BC BUILDING CODE INTERPRETATION COMMITTEE

File No: 24-0066 INTERPRETATION Page 1 of 2

Interpretation Date:	January 20, 2025
Building Code Edition:	BC Building Code 2024
Subject:	Separate dwelling unit exposing building face
Keywords:	Demising wall, roof, unprotected openings, exposing Building face, spatial separation
Building Code Reference(s):	9.10.8.1., 9.10.8.2. 9.10.12.2.(1), 9.10.14, 9.10.15.

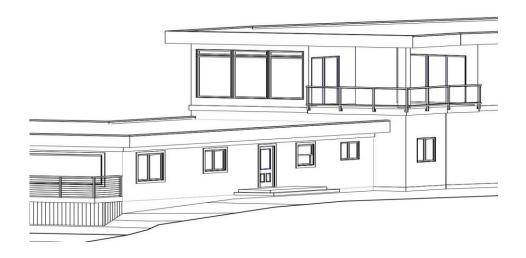
A two-storey addition to an existing single-storey unsprinklered house has been proposed to create an additional dwelling unit with a 1 hr fire-rated suite separation. The exterior wall of the second level of the addition faces and overlooks the existing single storey dwelling unit, and contains a large window and deck (see sketch).

- 1. Is the second floor exterior wall considered an exposing building face?
- 2. Are the windows in the second floor exterior wall required to be protected?

1. Yes.

The exterior wall of the new two storey addition meets the Building Code definition of an exposing building face.

2. No, with conditions.

The windows are required to be protected if the unprotected window area exceeds the permitted area within the spatial separation and exposing building face calculations of Section 9.10.14 or 9.10.15.

Sentence 9.10.12.2.(1) also requires the windows be protected if the adjacent dwelling unit is unsprinklered, and contains a skylight within 5m horizontally of the windows.
